City of Santa Fe

**Addendum Number 1
Request for Proposals (RFP) # '14/28/P**

**Storm Water Management Improvements
Arroyo Chamiso and Santa Fe River**

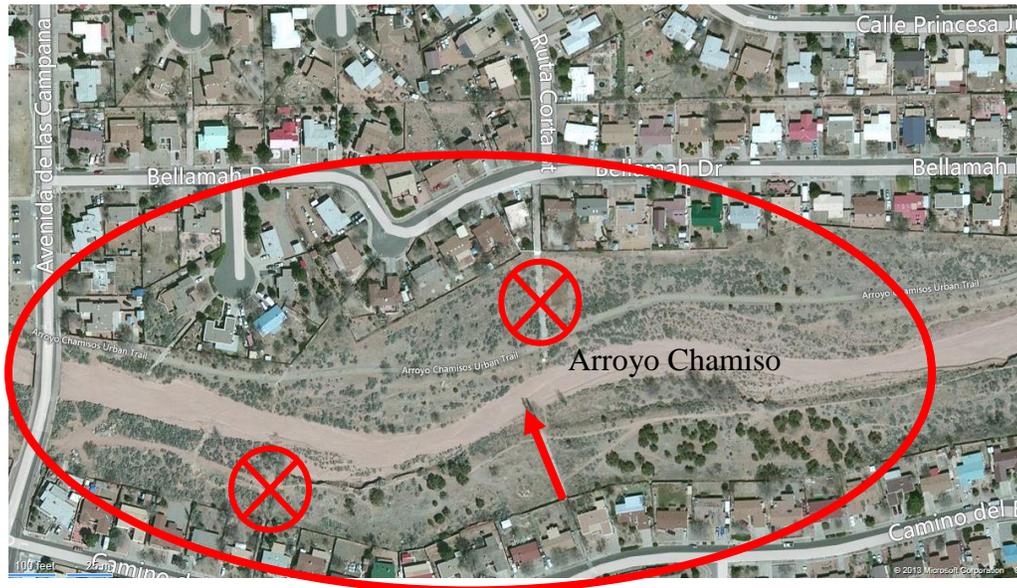
1. Copies of the pre-proposal meeting agenda and sign-in sheet are attached.
2. **Change in scope of work:** The project site on the north side of the Arroyo Chamiso, plus the western site on the south side of the arroyo, have both been removed from the project scope of work. See the "X" locations in the graphic below. The one drain from Camino del Bosque, on the south side of the arroyo remains in the scope.
